# DEVIATION REQUEST AND DECISION FORM

Project Name : Yucatan Convenience Store  
 Schedule No.(s) : 6501205016  
 Legal Description : Lot 1 Clearview West Filing No. 2 (4815 Yucatan Dr. Colorado Springs, CO 80911)

**PCD File # DEV-22-4**

**Figure 2 - 6. Guideline for determining the need for a major-road right-turn bay at a two-way stop-controlled intersection.**

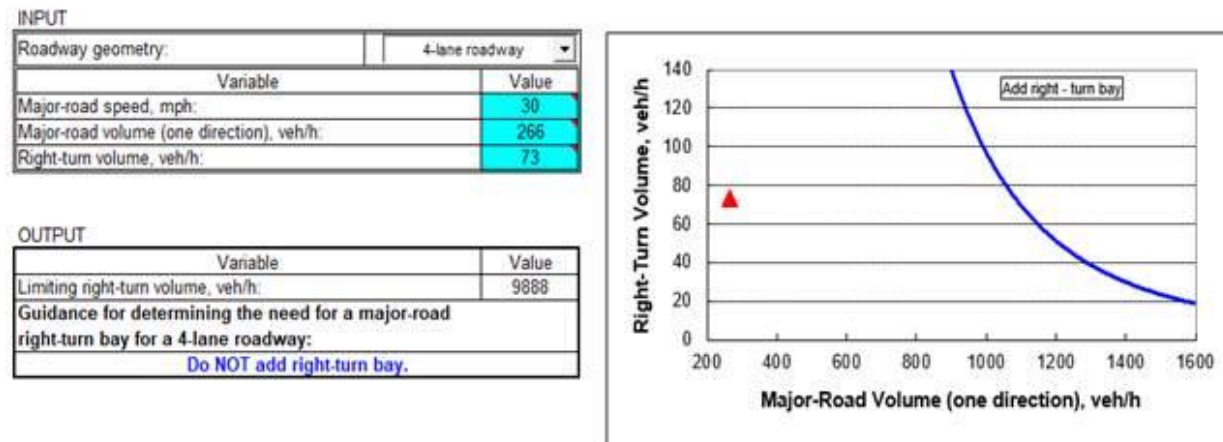
As you can see in Figure 2-6 below, the data point representing this site and its traffic/access volumes does not remotely approach meeting the threshold for suggested implementation of a right turn lane. A right turn volume of 73 veh/hr would require over 1000 veh/hr of through-traffic to be considered disruptive enough to warrant a right-turn lane (Compared against the Major-Road Volume of 266 veh/hr, a volume almost a quarter of that. This indicates that utilizing a through lane for right-turns onto the site will not be disruptive to through-traffic, nor to the functionality of the roadway or the Hancock/Yucatan intersection.
